AltoUpdate...

Premature Clutch Failure in the Mercedes 722.6 Resolved with Alto Torque Converter Clutch Plates...

Year/Model: C&E Class '97-On, S&SL Class '96-On, SLK230 '98-On, ML '99-On

MERCEDES 722.6 CONVERTER STACK-UP

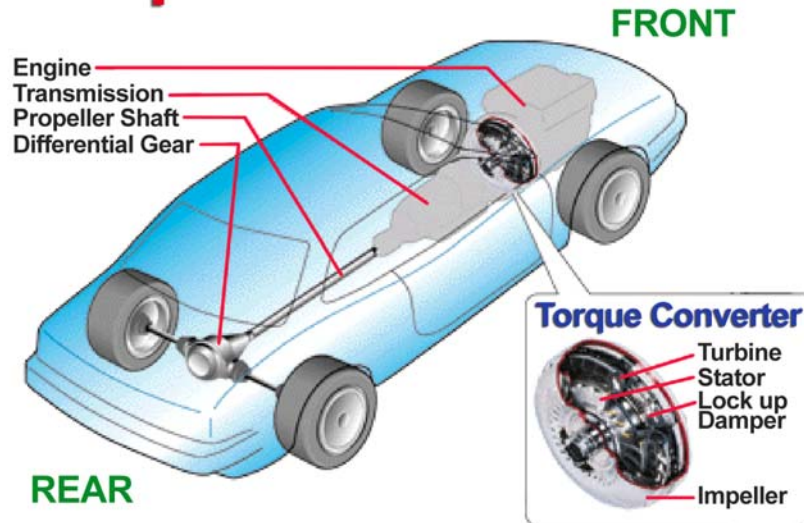
Problem: Many reports of premature clutch failure in the torque converter of the Mercedes 722.6.

Solution: Alto #s 141714 friction plate, 141715-177 and 141715-390 steel plates make up the lock-up device in the 722.6 torque converter. Alto has produced these high wear, high torque friction plates in Red Eagle® friction lining.

Alto#	Qty	Description	Specs.
141714	2	Red Eagle Frictions	.107"/2.72 mm
141715-177	2	Steel Plates	.069"/1.77 mm
141715-390	1	Steel Plate	.155"/3.9 mm
